VASY reports a deadlock in the IEEE 1394 "Firewire" standard

February 13, 1998

This document reports an error in the part of the state machine describing the asynchronous mode of the Link Layer protocol of the IEEE Standard 1394 "Firewire" high-speed serial bus. This error leads the protocol to a deadlock state. It was revealed by the use of formal methods (more specifically the ISO Formal Description Technique LOTOS and the software engineering toolbox CADP). A modification of the Link Layer state machine is proposed.

Figure 6-19—Link layer packet transmit/receive state machine

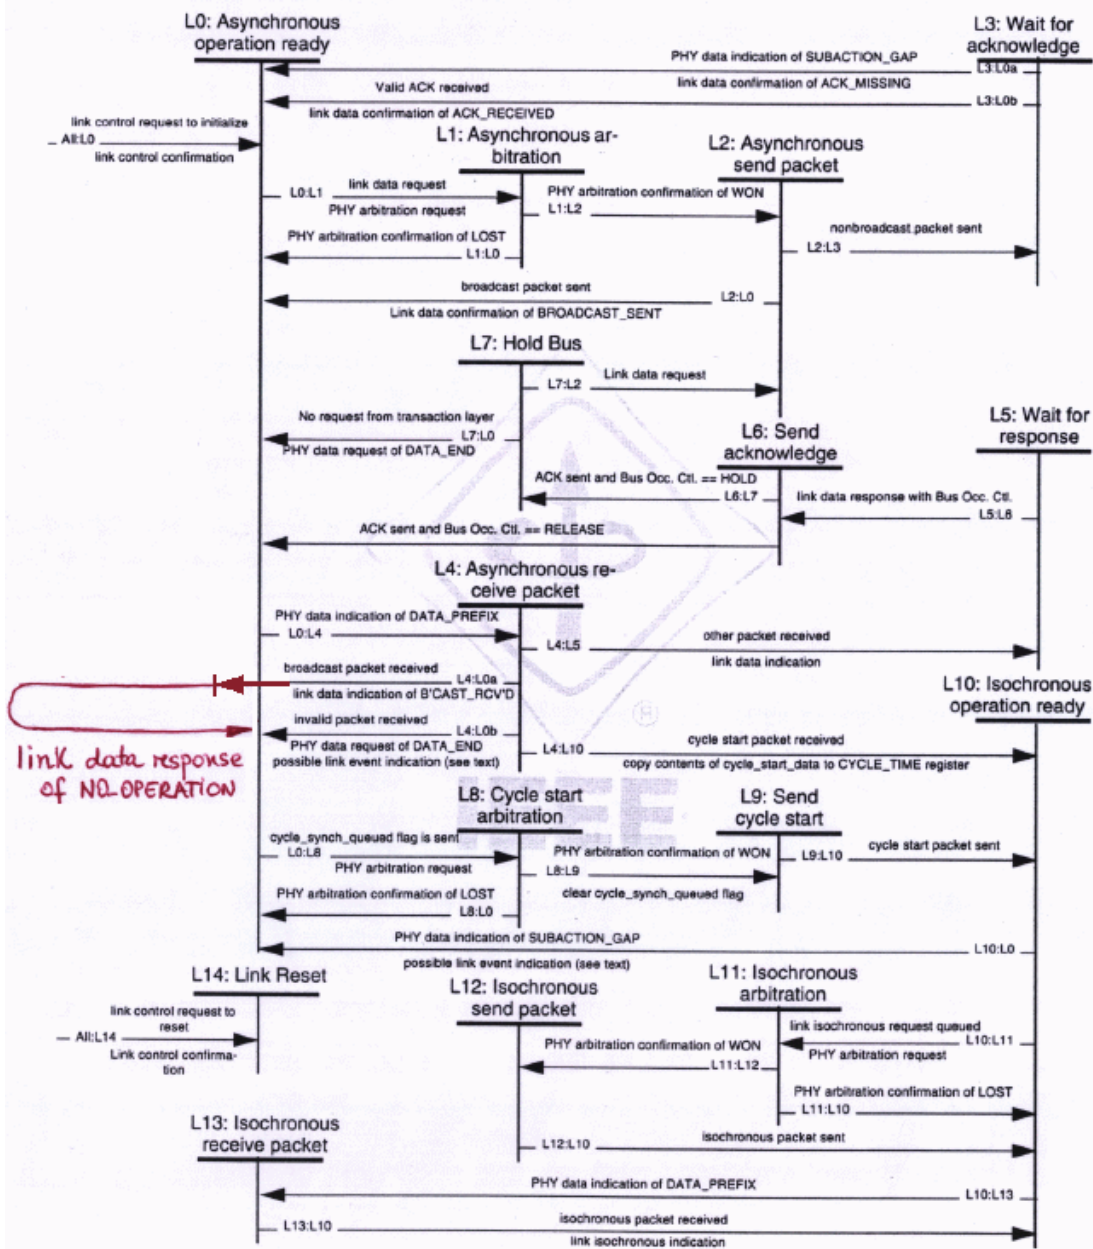
This deadlock is caused by the fact that, in the state machine diagram of the Link Layer (page 166 of IEEE Standard 1394), no Link Data Response can be accepted after a Data Indication following the reception of a broadcast packet.

Therefore, the Link Layer state machine given on page 166 of IEEE Standard 1394 should be modified as follows:

Precisely, the transition L4:L0a should be split in two successive transitions separated by an intermediate state:

- The first transition consists of the existing transition L4:L0a, whose target is modified: the transition no longer arrives in state L0, but in a new intermediate state.
- From this intermediate state, a second transition starts. It is labeled with the condition Link Data Response of NO_OPERATION and no action. The target of this transition is L0.
